TRANS/WP.29/GRE/2002/44
18 July 2002

World Forum for Harmonization of Vehicle Regulations (WP.29)

PROPOSAL FOR DRAFT AMENDMENTS TO DRAFT REGULATION ON
ADAPTATIVE FRONT-LIGHTING SYSTEM (AFS)

Transmitted by the Expert from Poland

Figure 1: Idea of allocation of the "shoulder part".

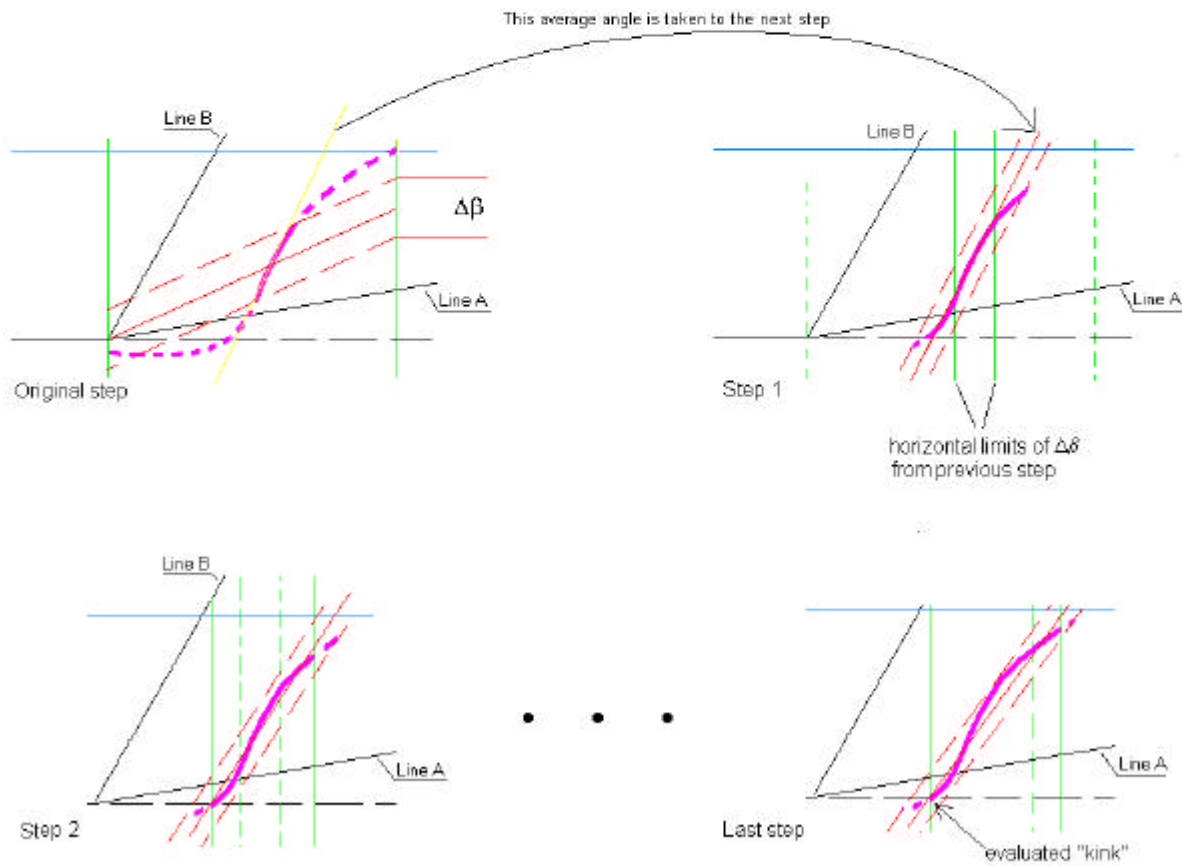
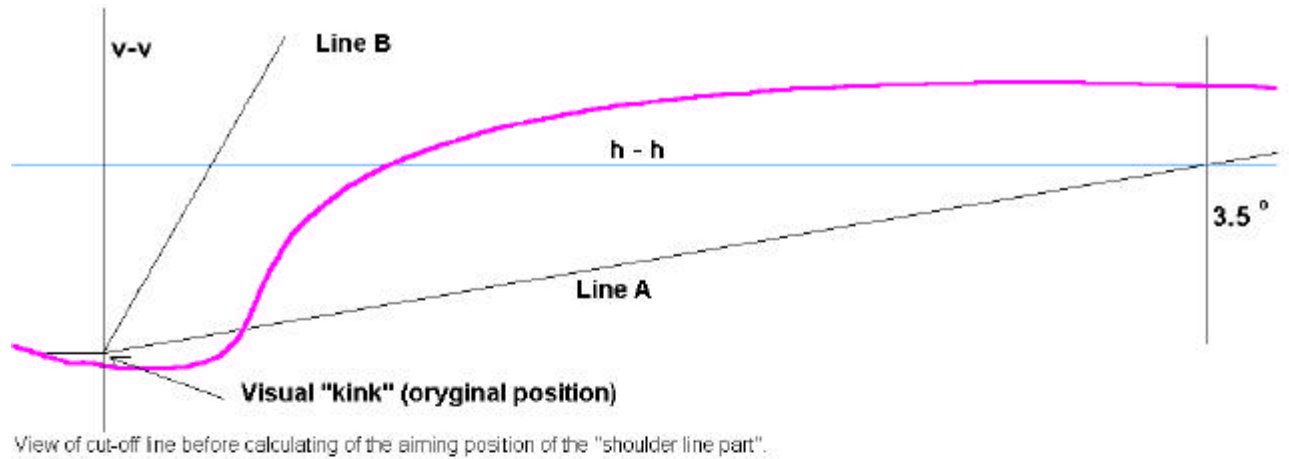
4.1.2. Horizontal adjustment:

Original "shoulder line part" co-ordinates (angle and kink point) of cut-off line is obtained by averaging of all co-ordinates of points in which $d^2(\log E) / d\beta^2 = 0$ scanned horizontally from $v-v$ to 3.5 degree the right and vertically under $h-h$, with the step not bigger than 0.1 degree. This is original "shoulder line part" and their co-ordinates (angle and "kink point") are calculated. Then the points with co-ordinates lying in bandwidth of ± 0.2 degree from original "shoulder line part" under $h-h$ are selected. In the next step selected co-ordinates are averaged as above giving next co-ordinates of "shoulder part" of "cut-off" line. Then selection and averaging is repeated until the next average co-ordinates of "shoulder part" do not differ from the preceding one.

An example of this procedure is shown on figure 1.
